CHILDREN'S HOSPITAL
OF ORANGE COUNTY
455 S. Main St.
Orange, CA 92668-3874

TOWER II

MECHANICAL DETAILS -
PIPE SUPPORT DETAILS

M10.06

SCALE
NONE

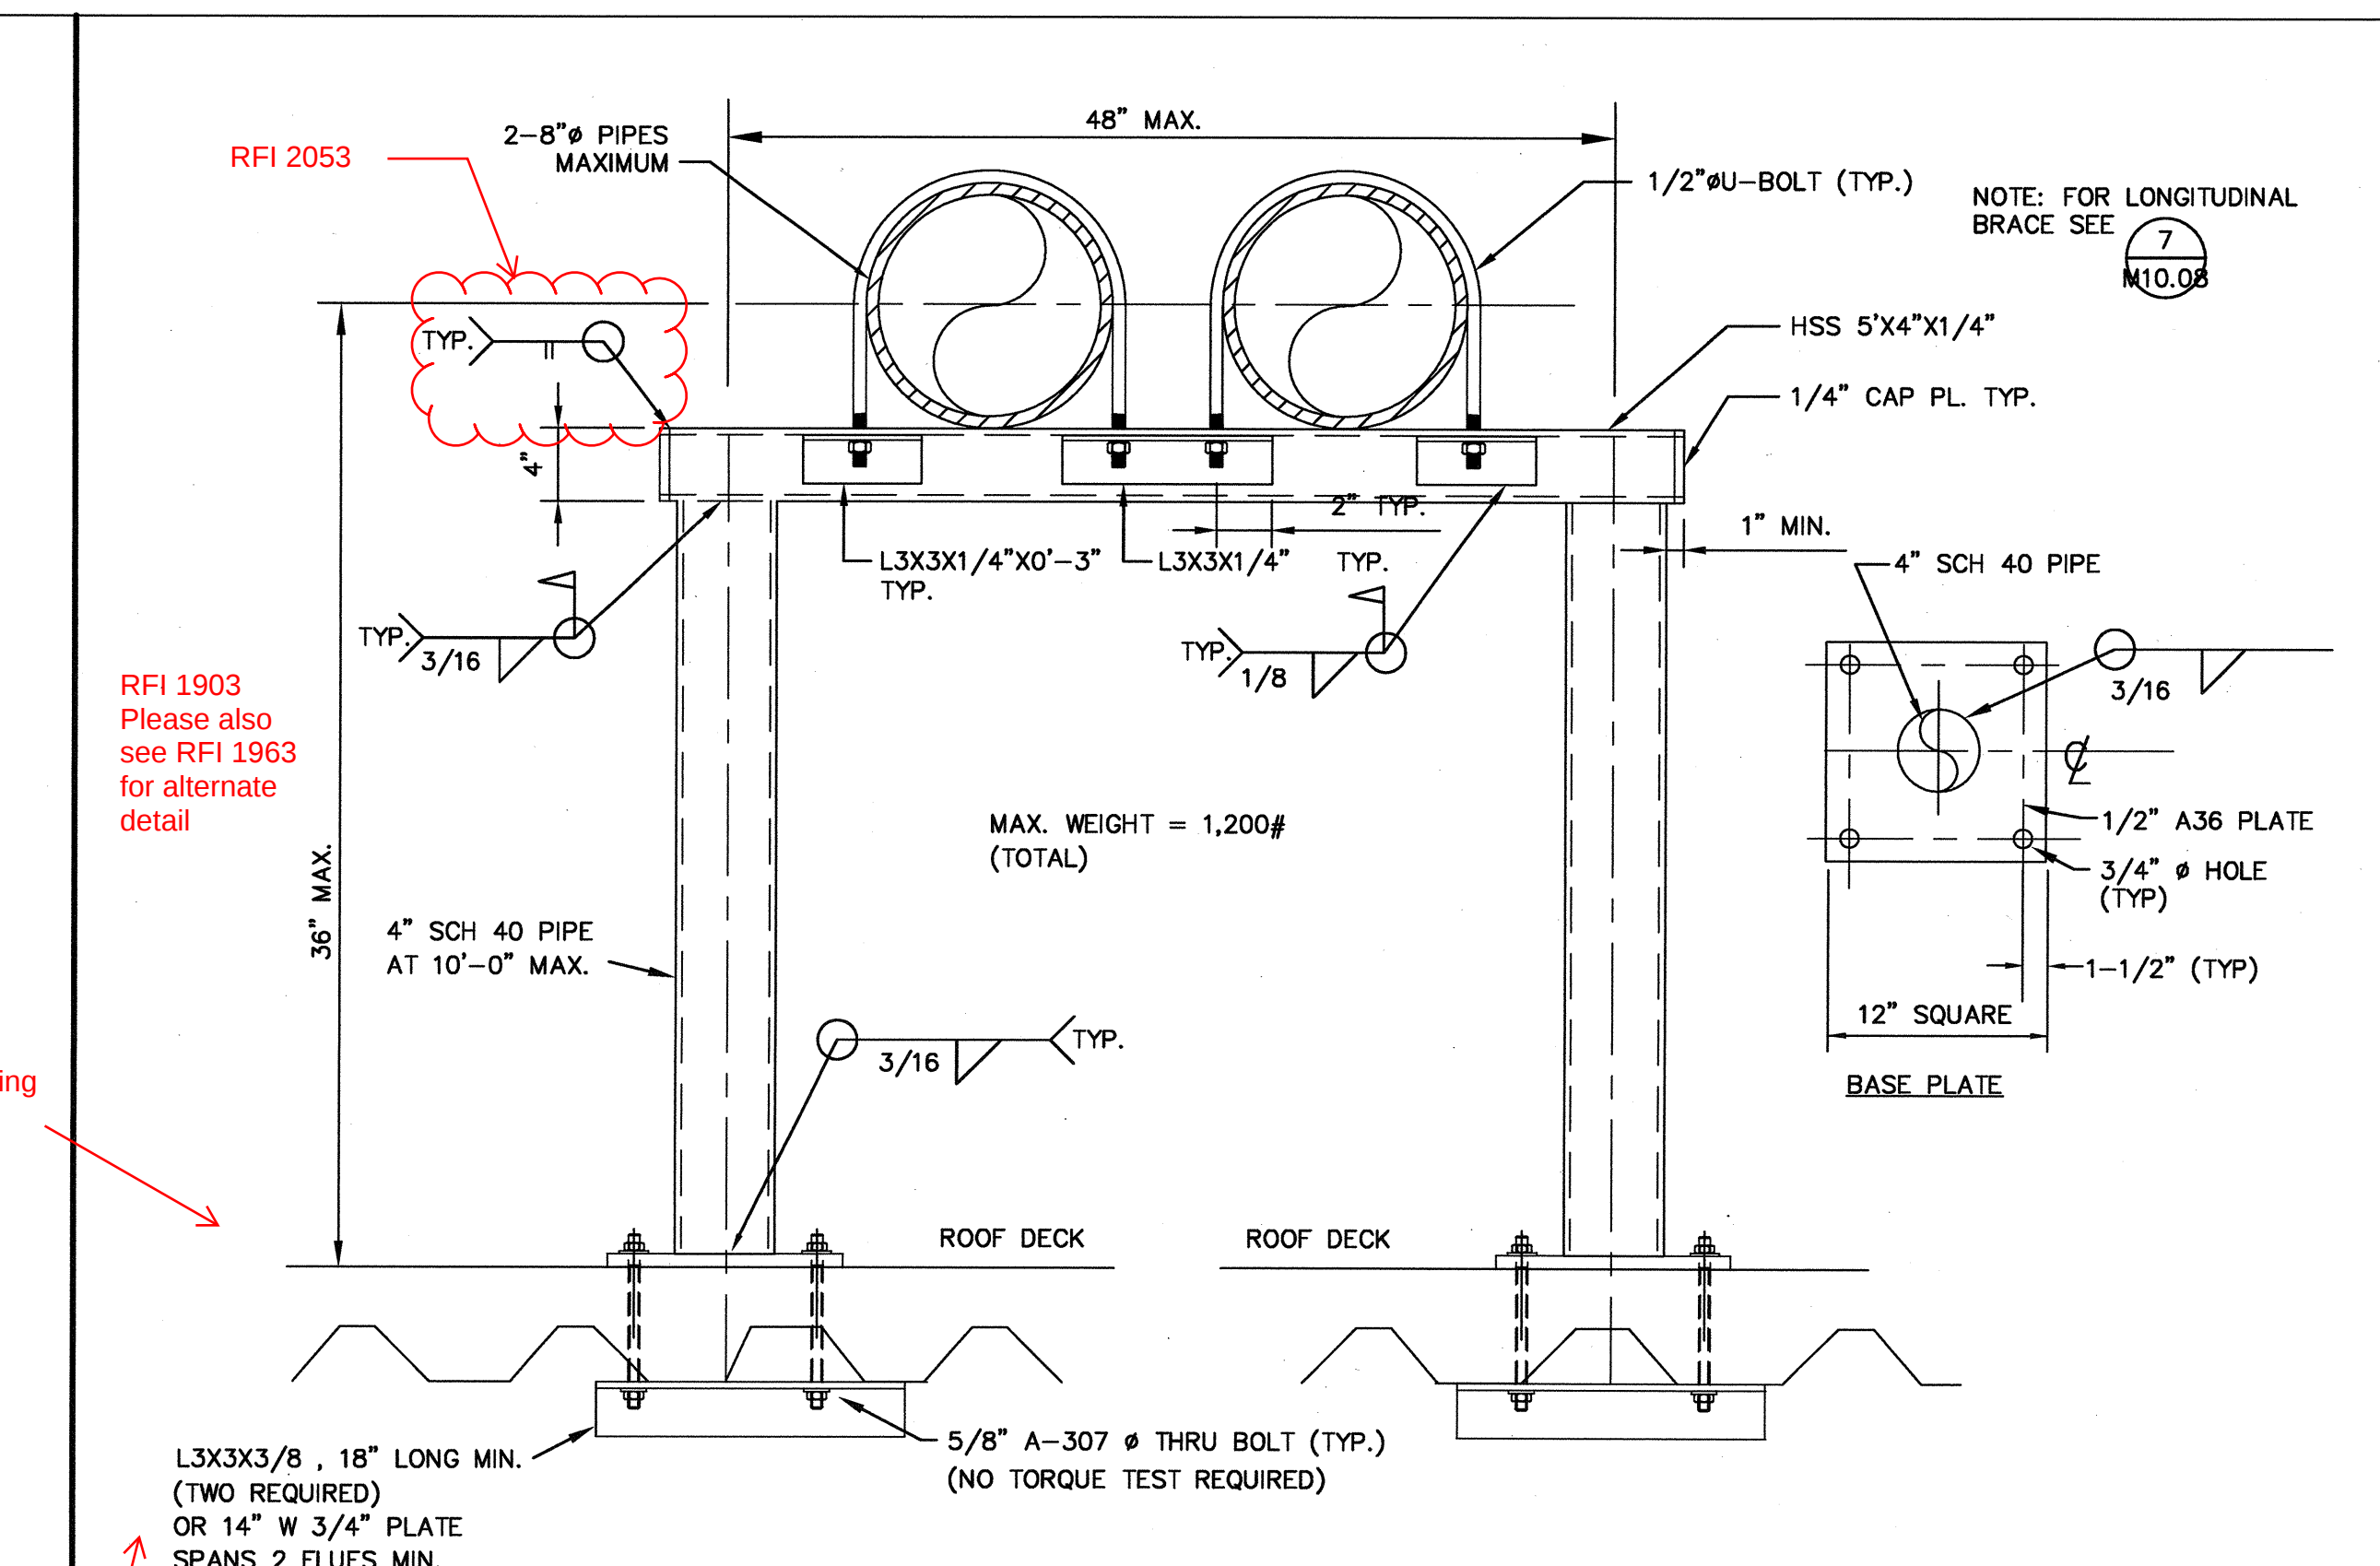
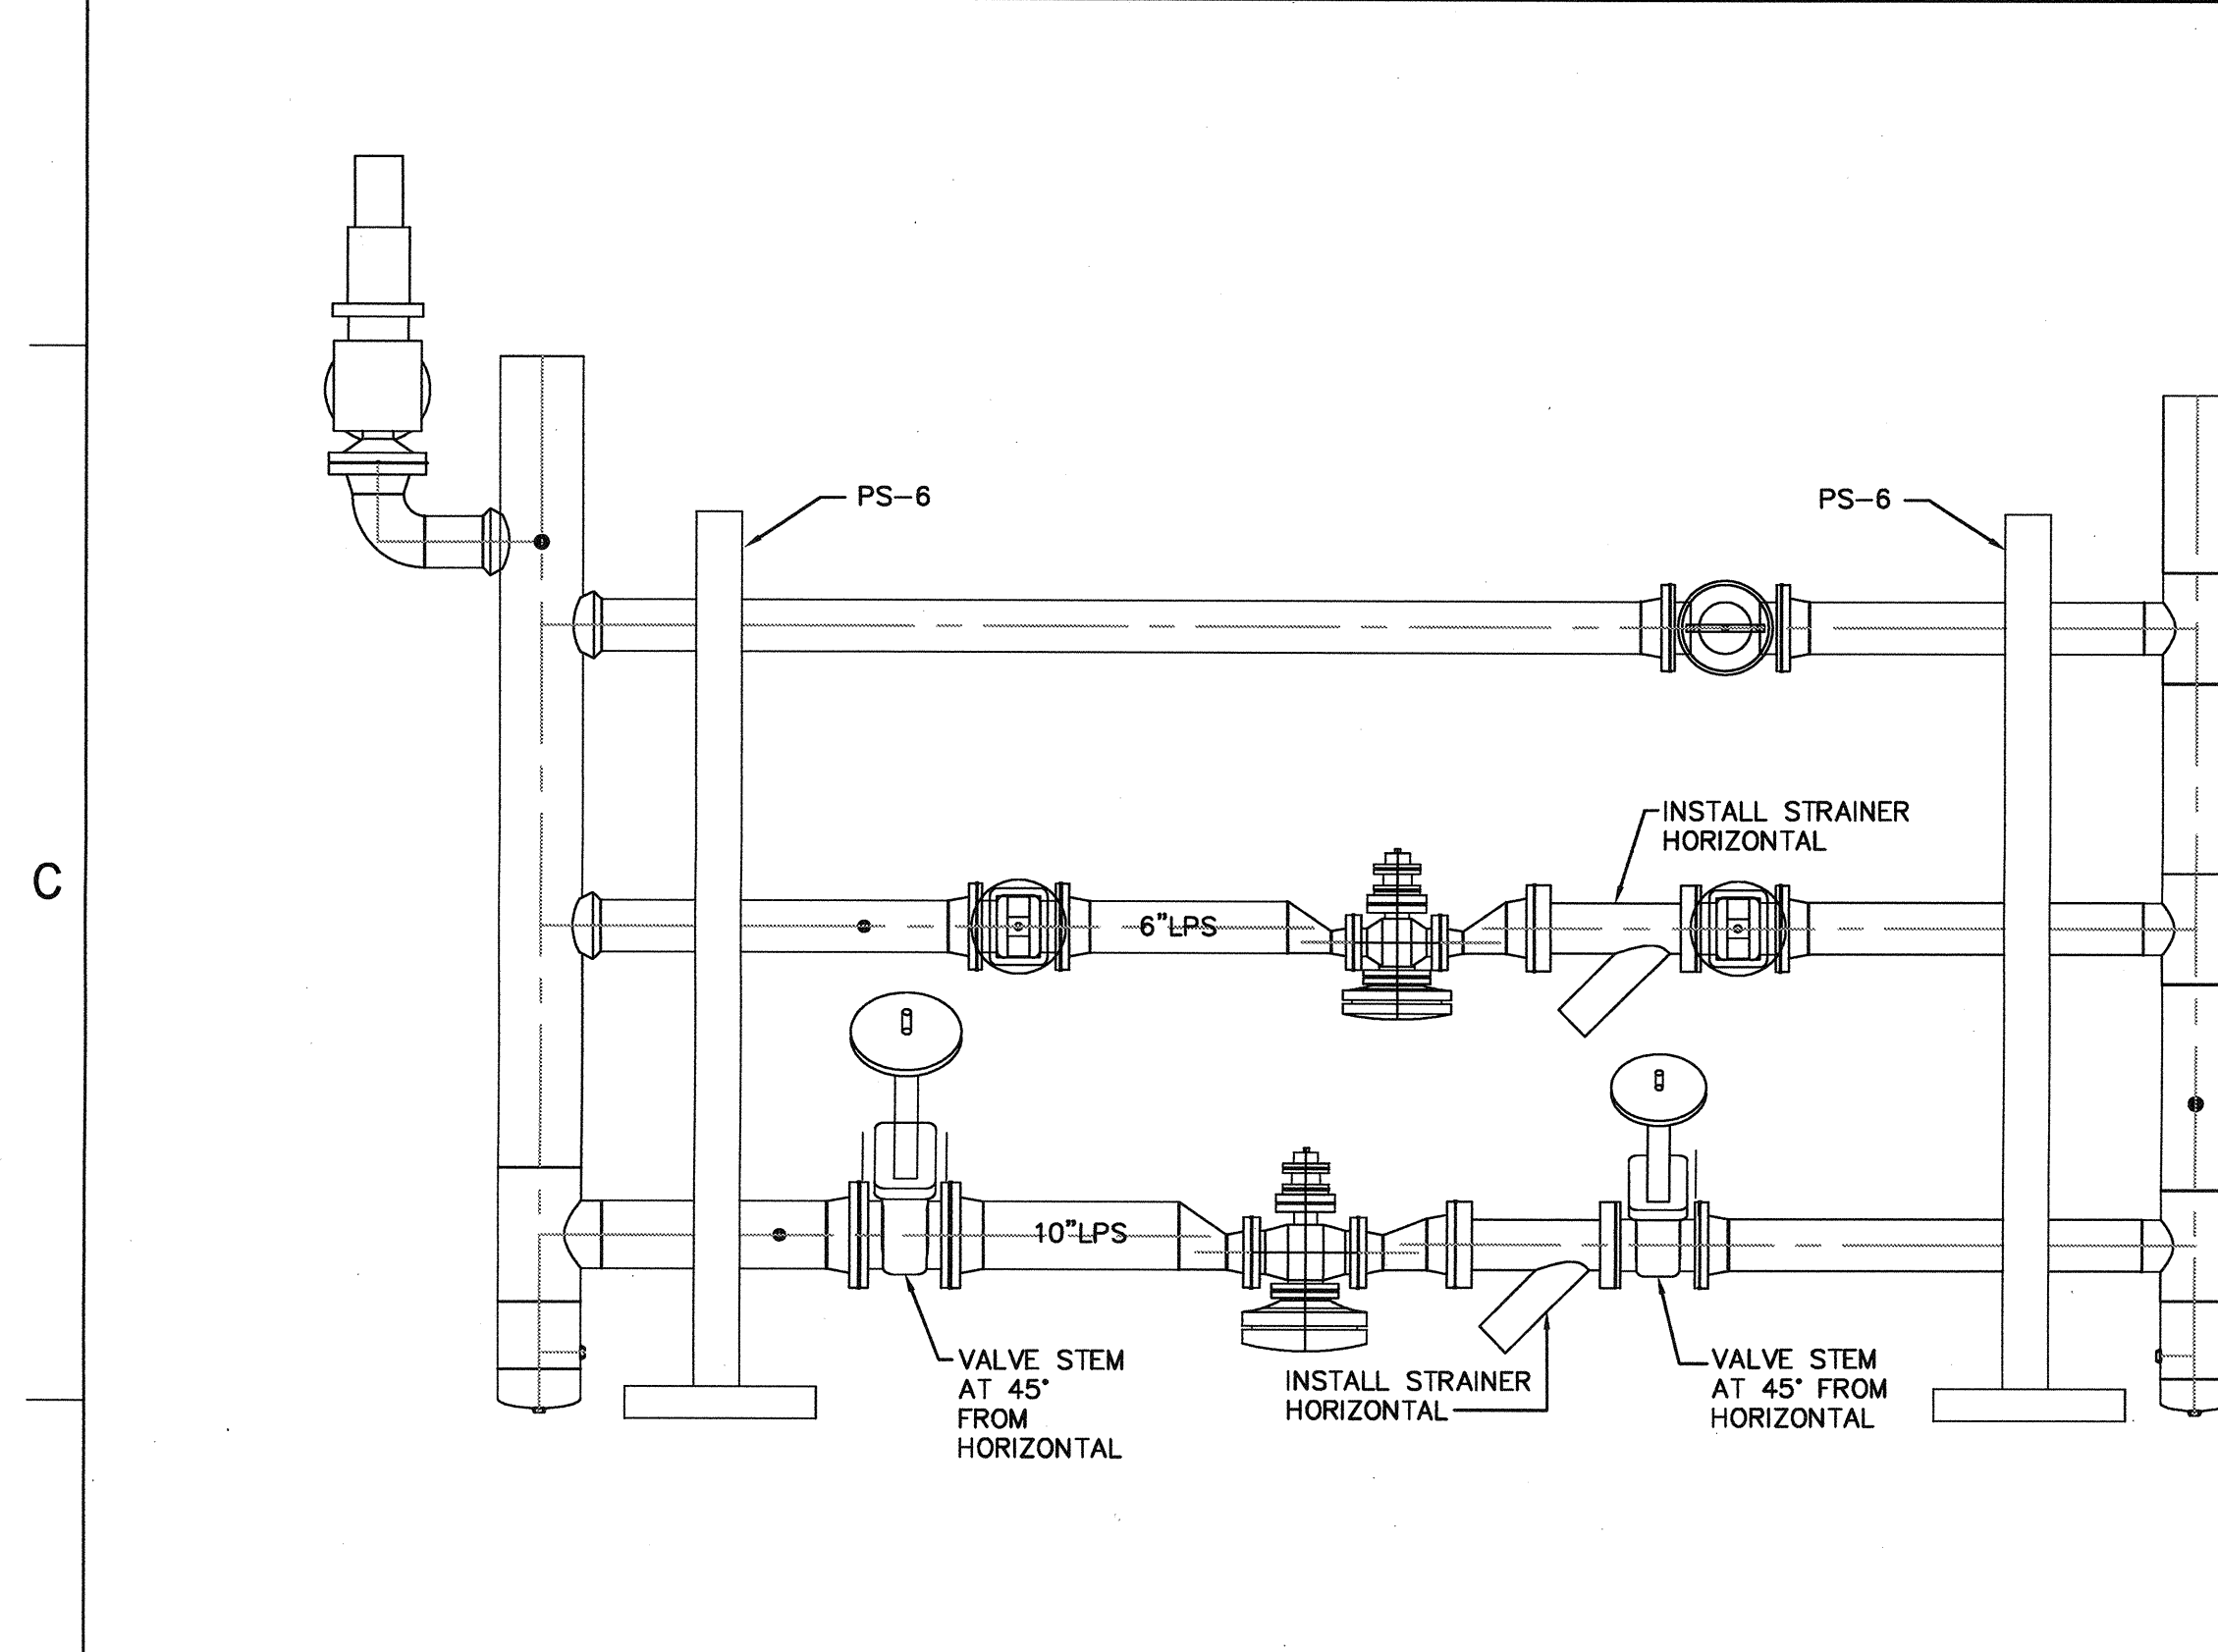
RFI #3944

Temperature controls conduit
acceptable to attach to pipe and duct
supports on roof.
